Reference	ISO/DIS 13628-4.2 (Ed 2)	Committee	ISO/TC 67/SC 4
Edition number	2	Vienna agreement	ISO lead
English title	Petroleum and natural gas industries -- Design and operation of subsea production systems -- Part 4: Subsea wellhead and tree equipment		
French title	Industries du pétrole et du gaz naturel -- Conception et exploitation des systèmes de production immergés -- Partie 4: Équipements immergés de tête de puits et tête de production		
Start date	2008-12-04	End date	2009-02-04
Opened by ISO/CS on	2008-12-04 00:07:14	Closed by ISO/CS on	2009-02-06 00:07:16
Status	Closed		
Voting stage	Enquiry	Version number	2
Note

Document: ISO DIS 13628-4.2

Figure 1 –Signature of FSC hydraulic actuated valve – Test at High Pressure

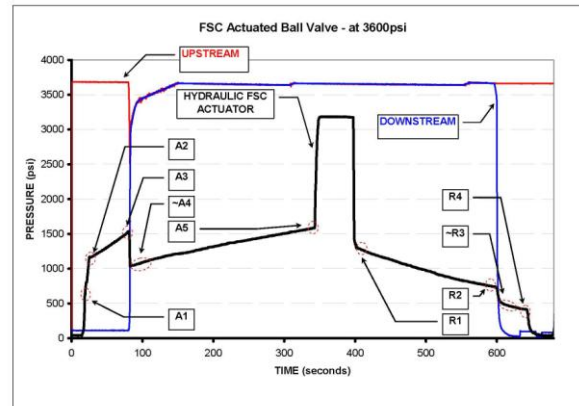
Since 2001, Brazilian oil industry has been using design validation tests (PVT) and their cycling tests to estimate wear-out and performance degradation (sealing and actuation) along them. As quality assurance is employed in prototype and also in products, it is considered that PVT results are representative of design and can be used as reference to future product valves. This method is capable to estimate the expected performance degradation due to cycling, which can be used as a FAT acceptance criteria parcel.

To measure and record actuator forces (hydraulic pressure or torque), in order to provide more consistent results, less sensitive to executor mishandling, we suggest to use signature tool as a standard procedure – see figure. For more details/info double click in pdf icon. It also provides objective evidences of acceptable functional behaviour in a standardized way - qualitative (as signature “shape”) and quantitative (A1..A5, R1..R4 key-point tables).

For hydraulic actuated fail-closed (open) valve the minimum actuator pressure to open (close) and maximum allowable actuator back-pressure to close (open) shall be measured and recorded before and after to perform life cycle/endurance testing.

For rotary actuated valve the minimum torque to open and close shall be measured and recorded before and after to perform life cycle/endurance testing.

The actuator performance degradation (difference of actuator pressure or torque between before and after the life cycle/endurance testing) shall be taken into account to meet clause 7.10.4.3 and to define FAT acceptance criteria.

Forces or torques measurement and recording method shall be based on method presented herein.
